Technical Service Information

THM 4L60 (700-R4) REVERSE INPUT HOUSING AVAILABILITY

Figure 1

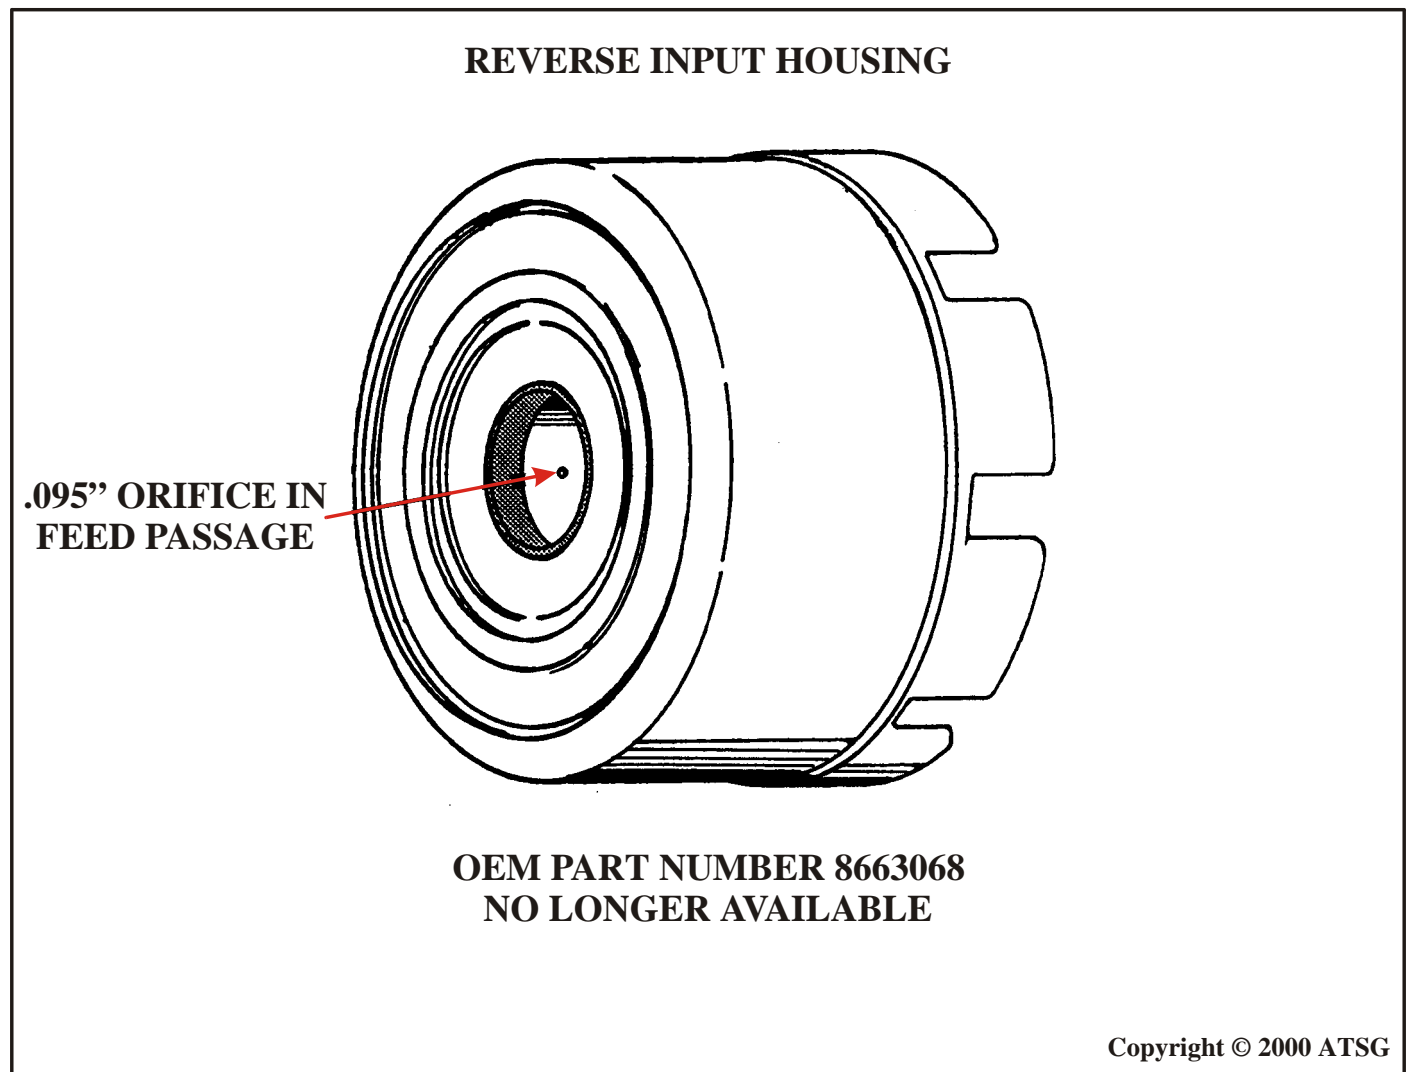
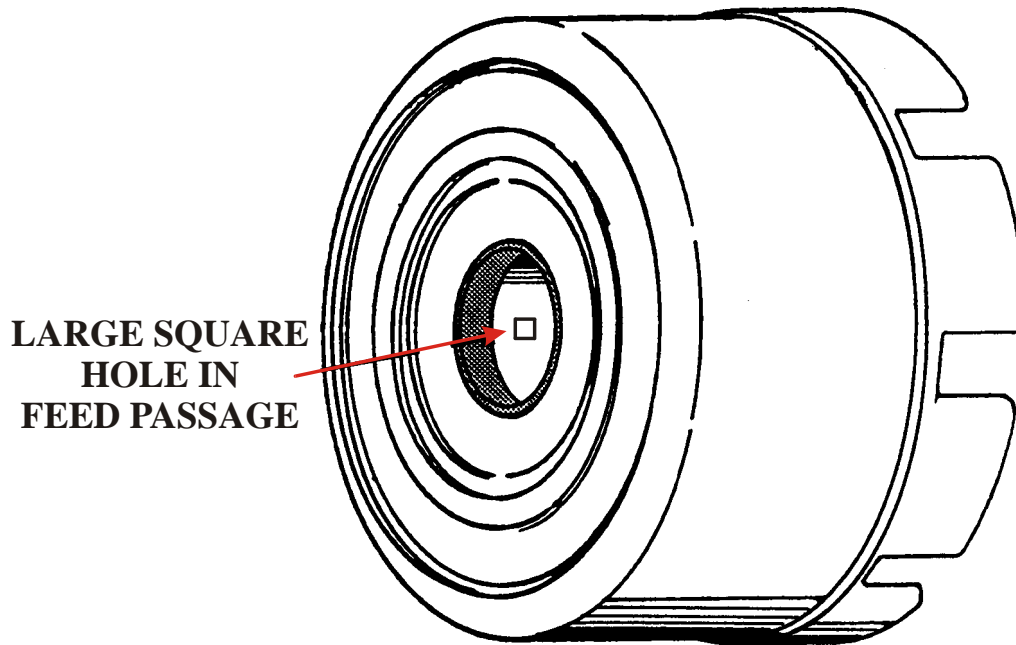
Powertrain Division of G.M. has informed us that the Reverse Input Housing for the 1987 thru 1992 model 4L60 transmission, OHM part number 8663068, is no longer available. This is the Reverse Input Housing with the .095" orifice in the feed passage between the sealing rings, as shown in Figure 1.

All of the previous model Reverse Input Housings, 1982 thru 1992, have been replaced by the 1993 model housing, OEM part number 8681295. This is the Reverse Input Housing with the large square hole in the feed passage between the sealing rings, as shown in Figure 2.

Anytime that you order the previous model part numbers, it will automatically supercede to the 93 model Reverse Input Housing and no other changes are required. This will create a firmer garage shift into Reverse on 1987 thru 1992 models, but is not an objectionable concern. There is now only one Reverse Input Housing available for ALL models of the THM 4L60 (700-R4), OEM number 8681295, as shown in Figure 2.
